Zoning & Planning Committee Agenda

MEMORANDUM

RE: **#88-20 Discussion and review relative to the draft Zoning Ordinance**
DIRECTOR OF PLANNING requesting review, discussion, and direction relative to the draft Zoning Ordinance.
Other docket items to be taken up within the context of Zoning Redesign include #30-20, #38-20, and #148-20

Courtyard Requirements and Parking
 Illustration shows N District

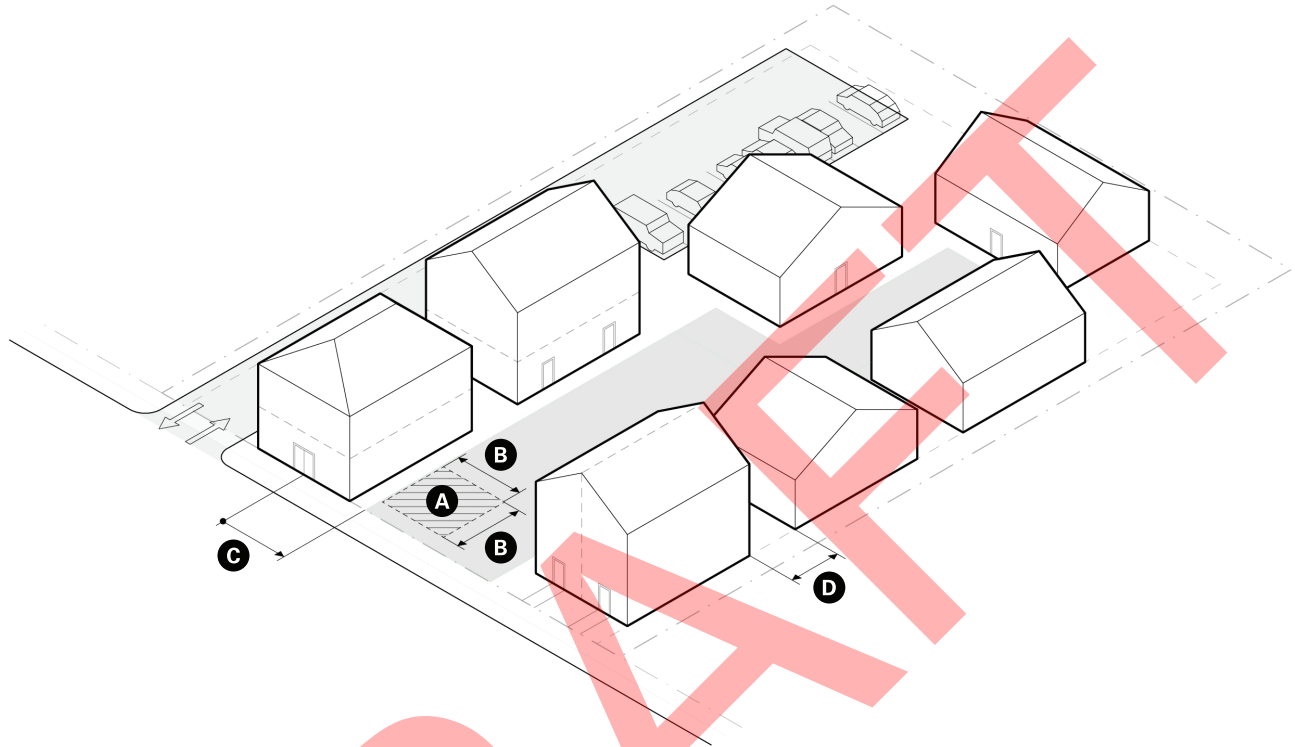
- Establishing a minimum distance between each building of 15 feet (Sec. 3.5.3.C.4) Previous versions had no required minimum distance. Rather than rely on the building code, which requires a variety of distances based on multiple factors (construction type, occupancy, fire-resistance rating, etc.), we have worked with our consultant to determine an appropriate distance that not only satisfies the building code, but also the neighborhood context.

~~3.4.~~ Buildings must be separated by a minimum distance of 15 feet.
